UNITED STATES PATENT AND TRADEMARK OFFICE

APPLICATION NO.	FILING DATE	FIRST NAMED INVENTOR	ATTORNEY DOCKET NO.	CONFIRMATION NO.
10/510,183	09/30/2004	Johan Ransquin	Q83823	6804
23373	7590	02/25/2008	EXAMINER	
SUGHRUE MION, PLLC			HALL, ASHA J	
2100 PENNSYLVANIA AVENUE, N.W.				
SUITE 800			ART UNIT	PAPER NUMBER
WASHINGTON, DC 20037			1795	
			MAIL DATE	DELIVERY MODE
			02/25/2008	PAPER

Office Action Summary	Application No.	Applicant(s)	
	10/510,183	RANSQUIN ET AL.	
	Examiner	Art Unit	
	ASHA HALL	1795

DETAILED ACTION***Claim Rejections - 35 USC § 112***

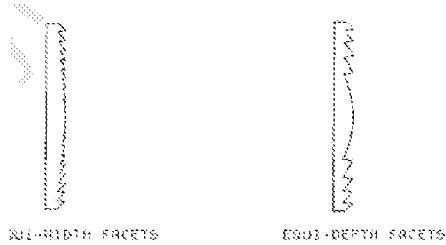
9. Applicant's arguments filed December 5, 2007 have been fully considered but they are not persuasive. The Applicant argues that the examiner also refers to page 305 as showing a "reflecting concentrator/Fresnel lens", but Osborn does not say anything about a reflecting concentrator, and a Fresnel lens is not such a device. The Fresnel lens simply concentrates. It is not a reflecting concentrator.

The Examiner respectfully disagrees. Osborn discloses a Fresnel lens with facets as shown in Figure 6. The Fresnel lens has total internal reflection facets as depicted below, as evidenced by Cassarly (**Handbook of Optics**, The McGraw-Hill companies, copyright 2001, p 2.10).
